Tarbert Ferry Terminal Upgrade Construction Licence Variation Request

Date: 27/01/2020

Drawing 49.08.05

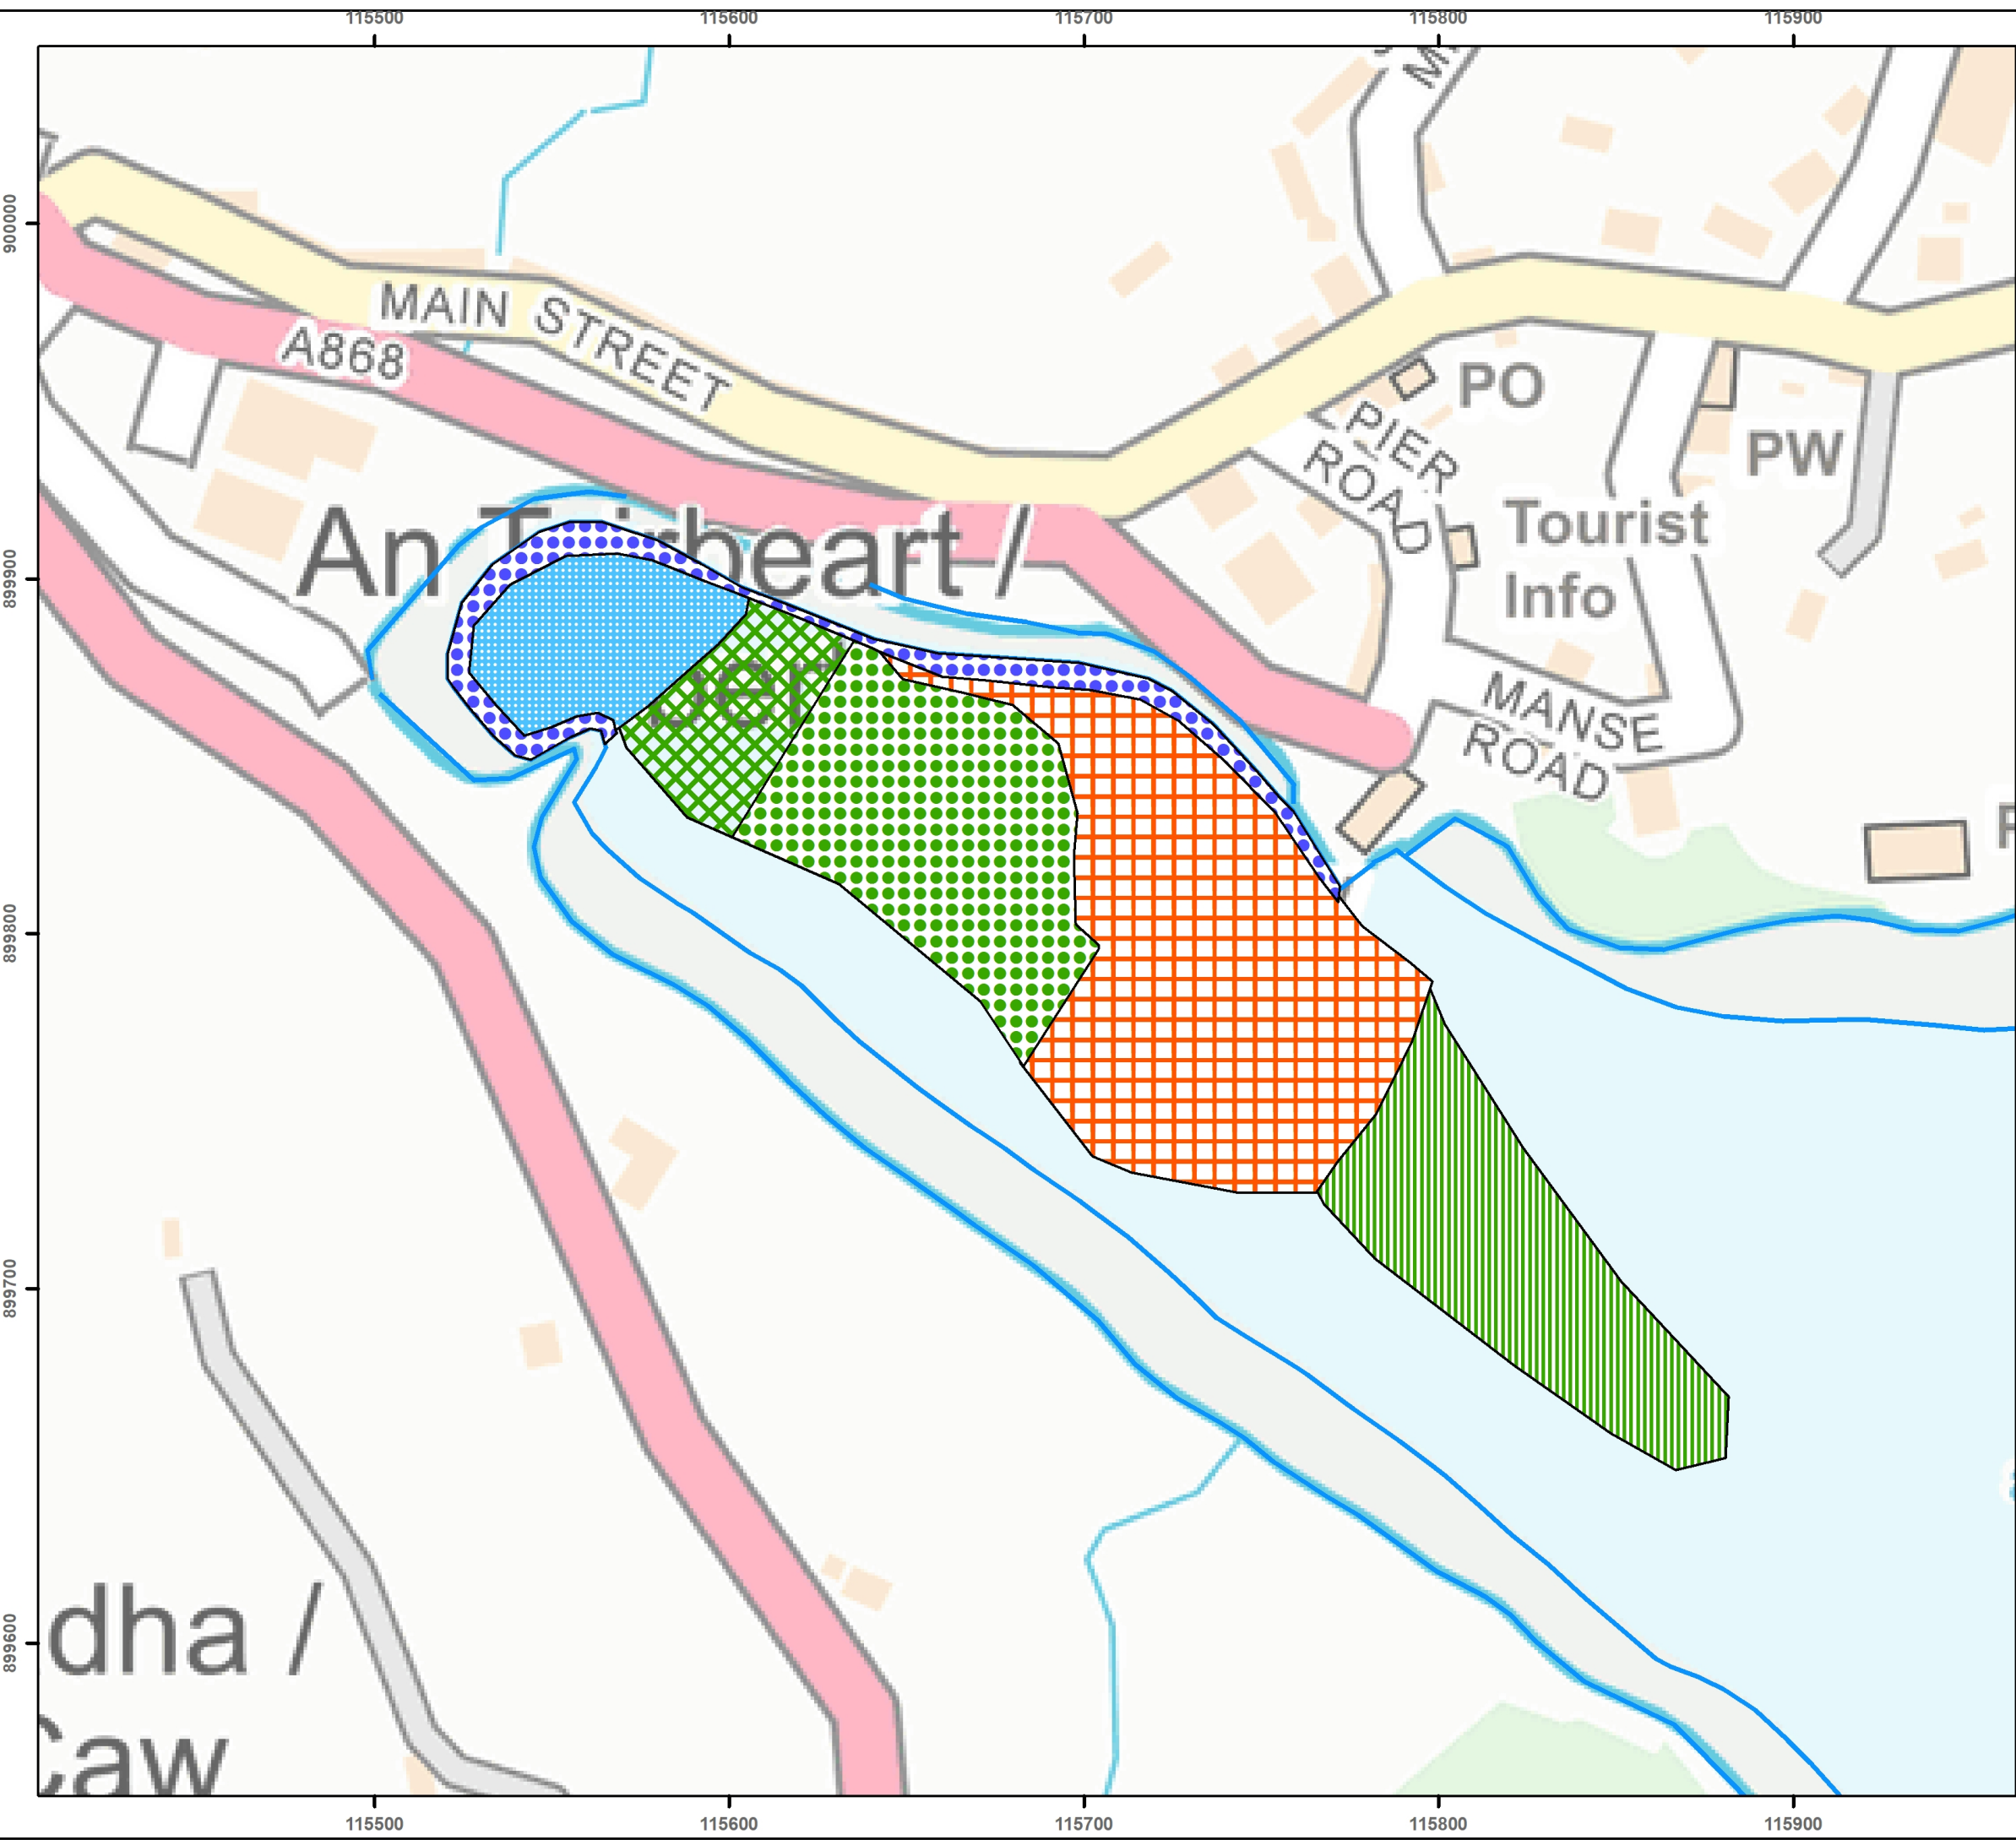
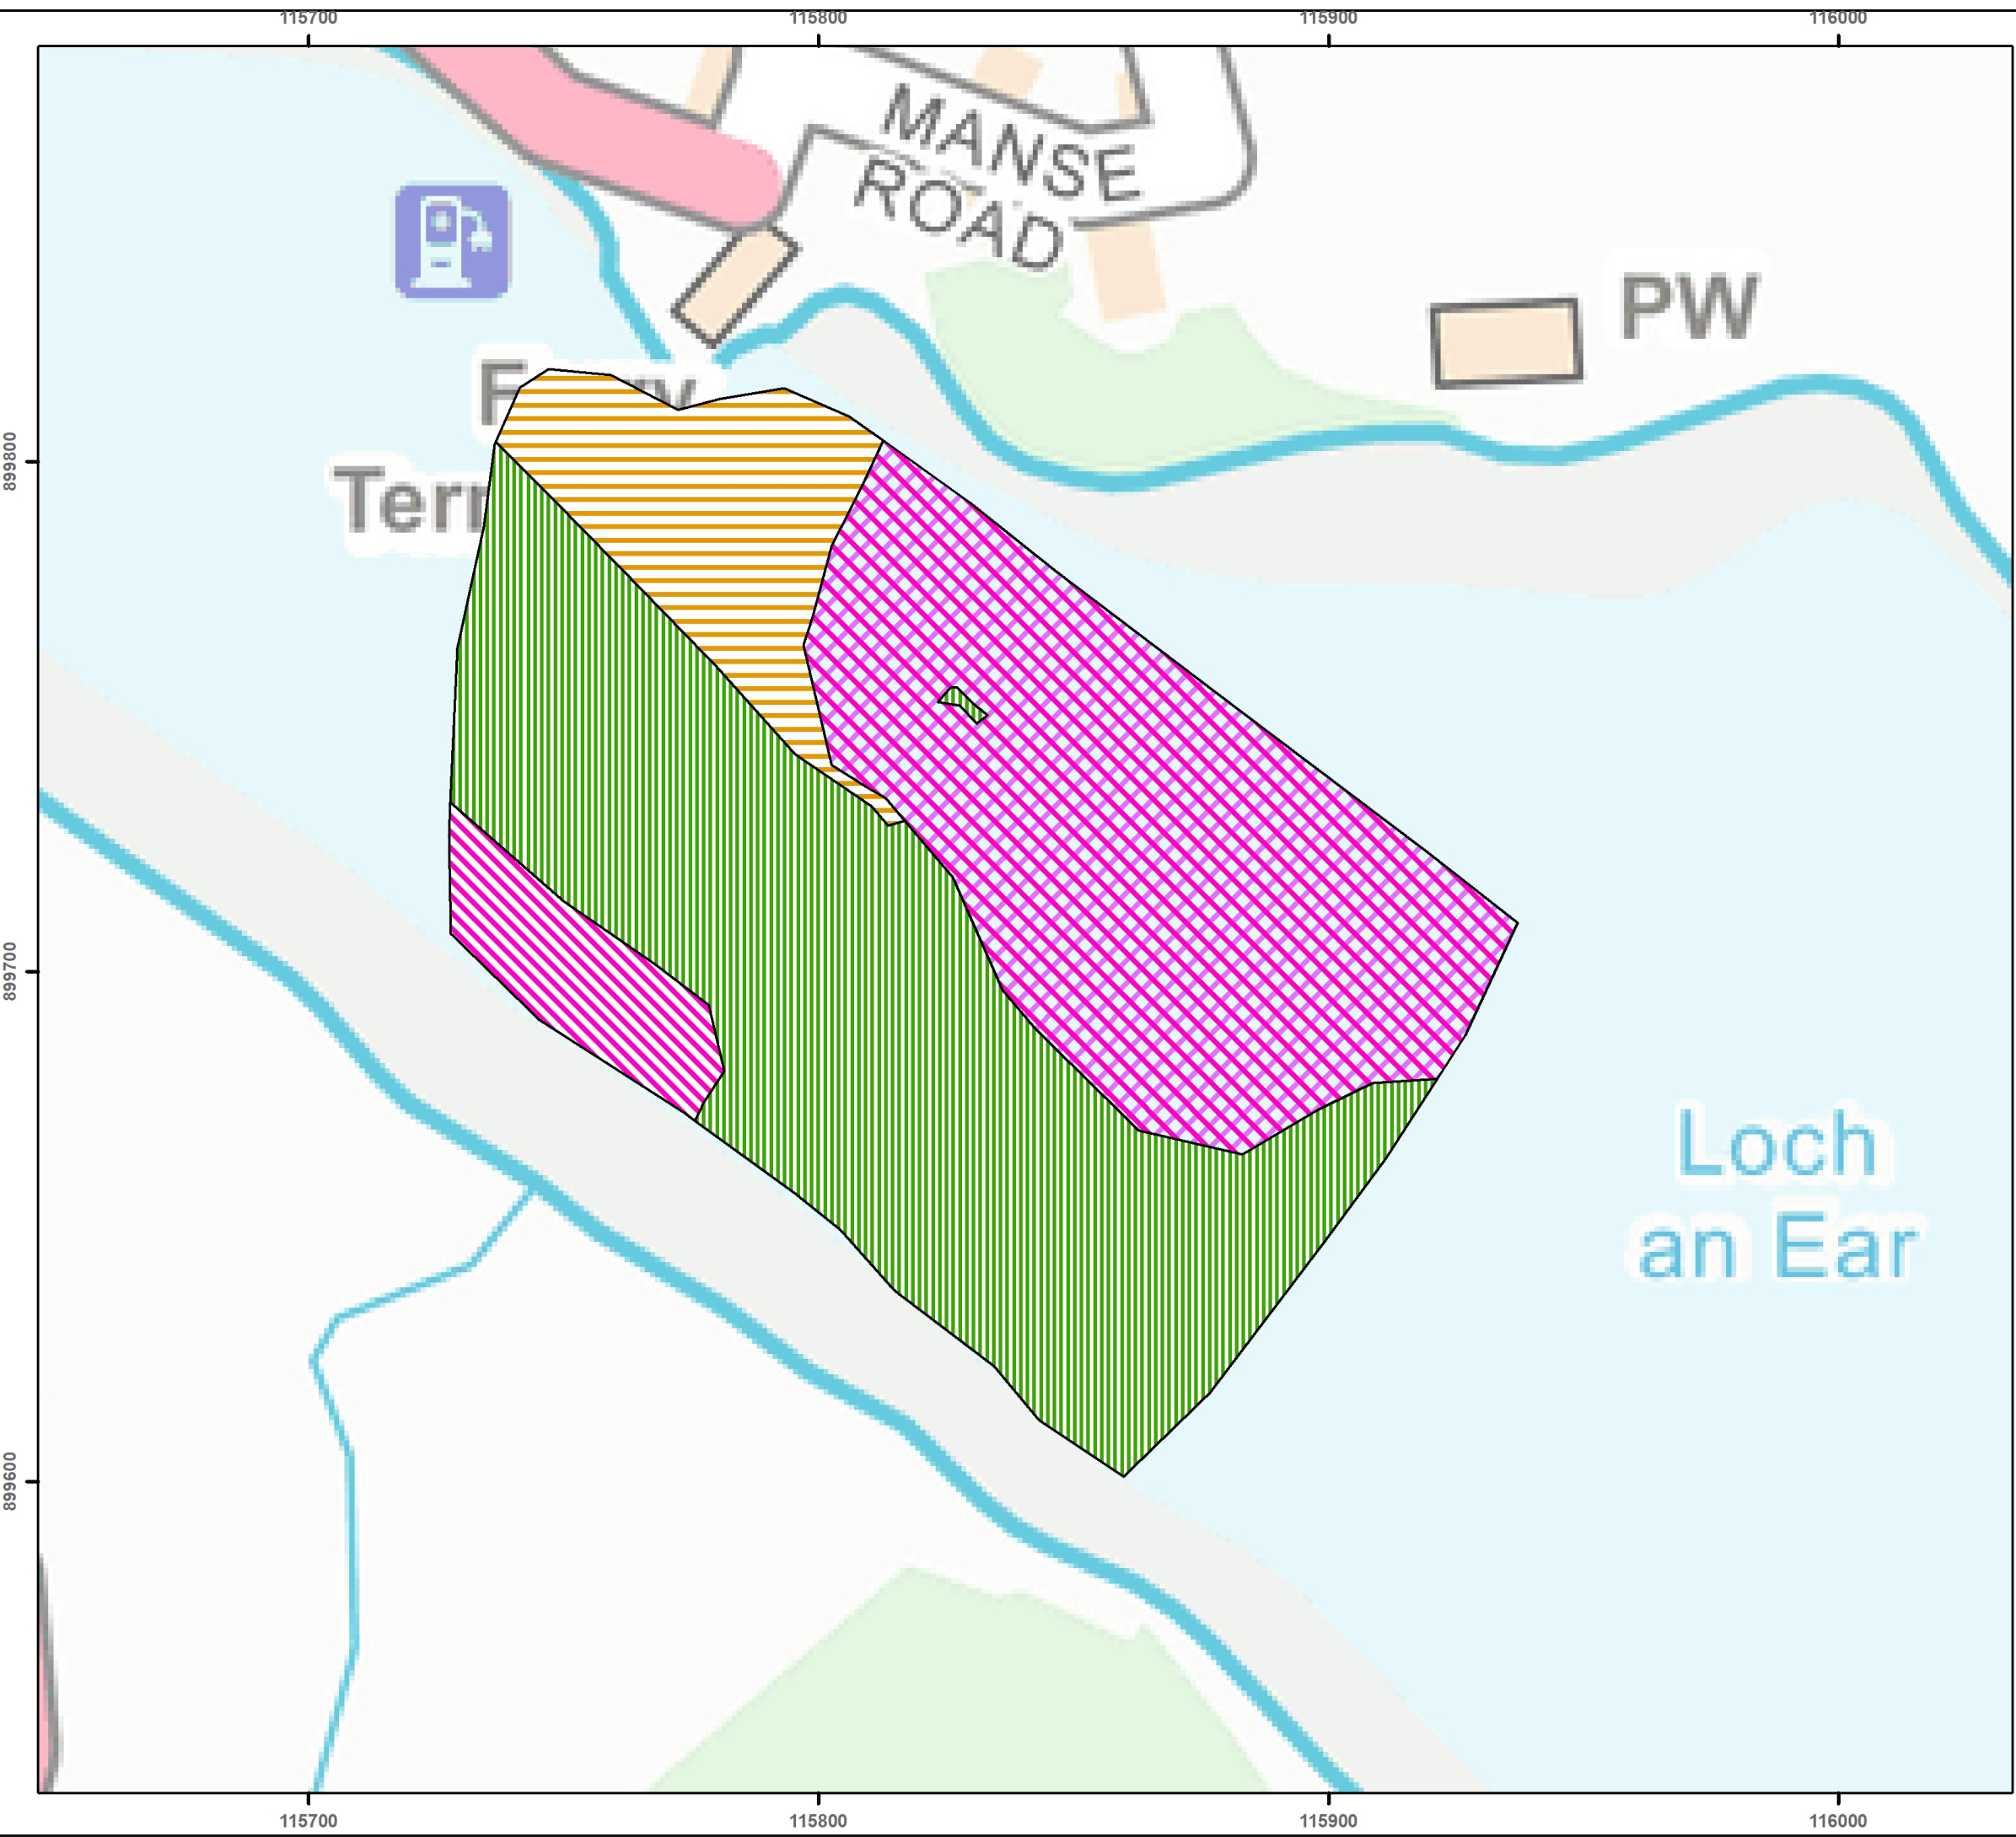
The area utilised for rock placement in the formation of the temporary infill bund to the north of the proposed pier, is mainly within the footprint of the subtidal benthic ecological habitats and species re-visit survey (APEM, 2018), conducted for inclusion within the EIAR (Affric, 2019) and shown in Drawings 49.08.05 and 49.08.06. Within the footprint of the temporary infill bund, the following biotope complexes were identified, and their ecological value determined in Table 3.2:

It is noted that there is a small area where the proposed bund will be located that has not been subject to benthic survey, this is due to the location being between the existing pier and the shore in shallow waters, which were not accessible by the survey vessel. As shown in Drawings 49.08.05 and 49.08.06, there are no other benthic habitats in the vicinity of greater ecological value of National, hence the areas of the bund location is not predicted to provide benthic habitat value of no greater than National level.
